Planning Approval Consistency Assessment Form

Assessment Name:	Relocation of a crossover cavern to Pyrmont and tunnel alignment optimisation
Prepared by:	Sydney Metro
Prepared for:	Sydney Metro and John Holland CPB Contractors Ghella Joint Venture (JCG)
Assessment number:	SMW07
Type of assessment:	Assessment under EP&A Act 1979, Division 5.2
Version:	Final
Planning approval No. (where relevant):	SSI – 19238057
Date required:	30 January 2023
iCentral number	SM-23-00014470

- Relocation of the crossover cavern from The Bays Station (east of The Bays Station box) to the western end of Pyrmont Station (refer Figure 6)
- Minor realignment of the tunnels to:
 - Achieve a crossover in-line and at grade with the future station platforms
 - Minimise horizontal curves along the tunnel alignment to improve operational efficiencies.

Figure 3 Proposed change - Pyrmont western site heavy vehicle movements

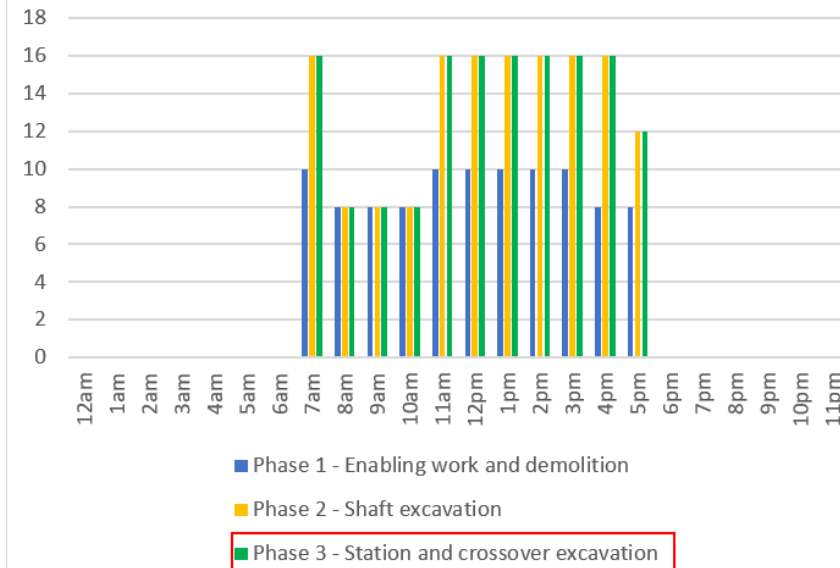
- No changes to the hourly or daily maximum heavy vehicle movements from the eastern construction site
- A maximum of 16 heavy vehicle movements per hour would be required during the daytime for Phase 3 works to/from the western construction site, which would include crossover cavern excavation. There would also be fewer heavy vehicle movements in the morning road network peak period, consistent with the Phase 1 and Phase 2 works. The maximum heavy vehicle movements required for each hour would be consistent with the Phase 2 works (western site) as assessed in the Response to Submissions Report/Traffic Update memo for the Approved Project
- Reduced total number of construction vehicles required at The Bays.

In summary, whilst there is an increase in the daily and hourly vehicle movements at the Pyrmont Station western construction site during the Phase 3 works, the numbers are consistent with the daily and hourly maximum vehicles assessed within the Response to Submissions Report for the Approved Project. The revised required numbers for the western site are shown in Figure 3 below.

Figure 4 EIS indicative alignment plan and proposed changes

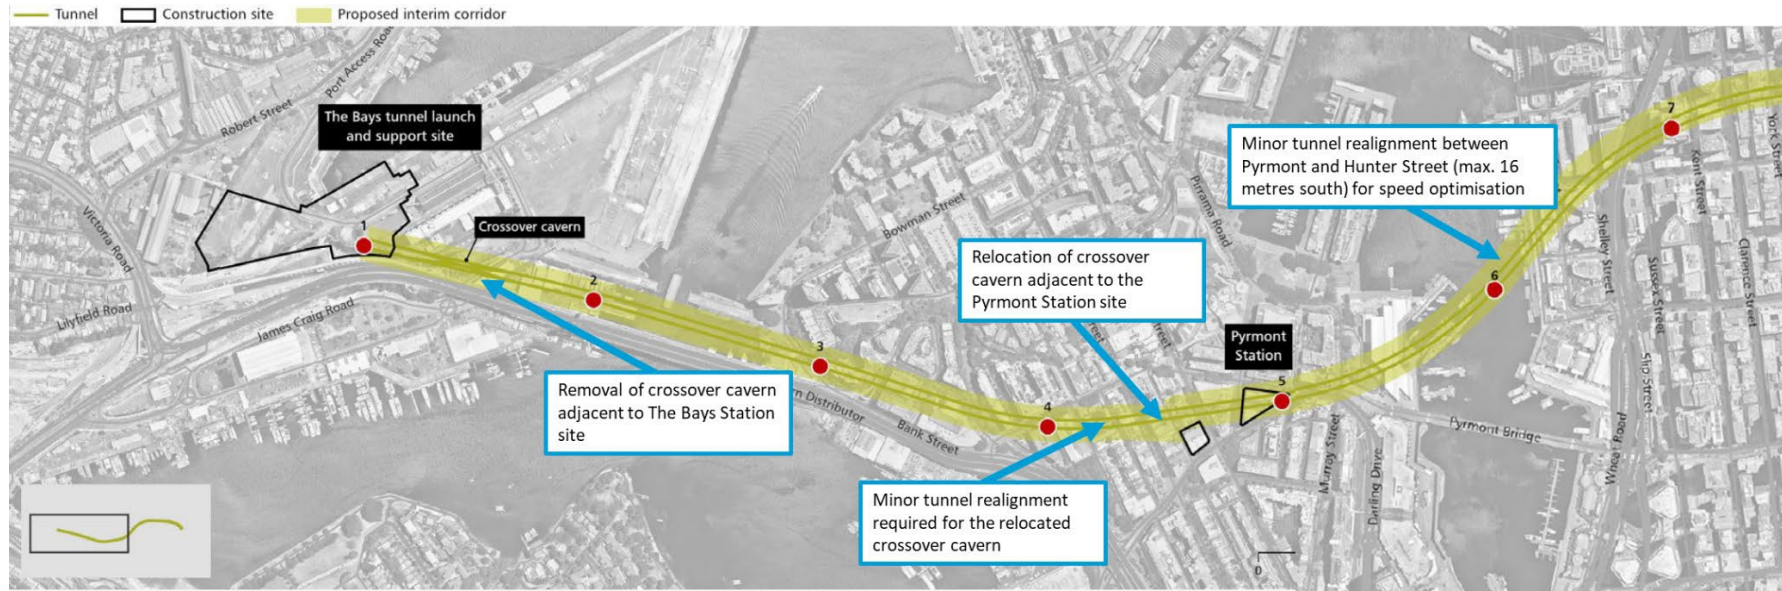
Refer to Figure 4 for the indicative tunnel alignment as assessed in the EIS for the Approved Project. The revised tunnel alignment is shown in Figure 5 which shows minor realignments required around Pyrmont and Darling Harbour. The proposed change in tunnel alignment would be substratum only (entirely underground) and the surface level footprint of the approved Pyrmont Station construction sites would not change.

Figure 5 Amended Sydney Metro West tunnel alignment

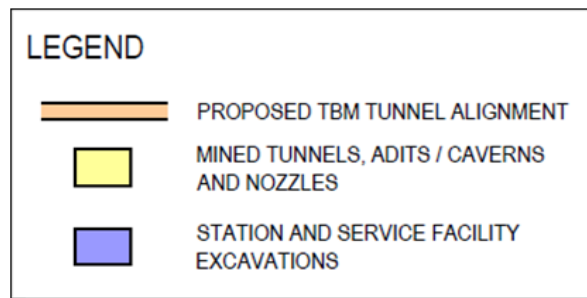
Relevant elements of the Approved Project	Proposed change
Tunnel alignment Section 5 of the EIS for the Approved Project identified the indicative location of the tunnel alignment (Figure 5-1 to Figure 5-3 of the EIS). The total tunnel length between The Bays and Sydney CBD is about 3.5 kilometres, of which about 2.3 kilometres will be excavated by tunnel boring machines. The sections of the indicative tunnel alignment relevant to this Consistency Assessment are shown in Figure 5.	This Consistency Assessment includes minor tunnel realignments between The Bays and Hunter Street Stations. The relevant sections of the approved tunnel alignment, and the proposed revised tunnel alignment is shown in Figure 4 and 5. The proposed change in tunnel alignment is located entirely underground (with a maximum realignment of around 16 metres) and the depths of the realigned tunnels would be similar to the relevant sections of the approved tunnel alignment (refer Figure 5)
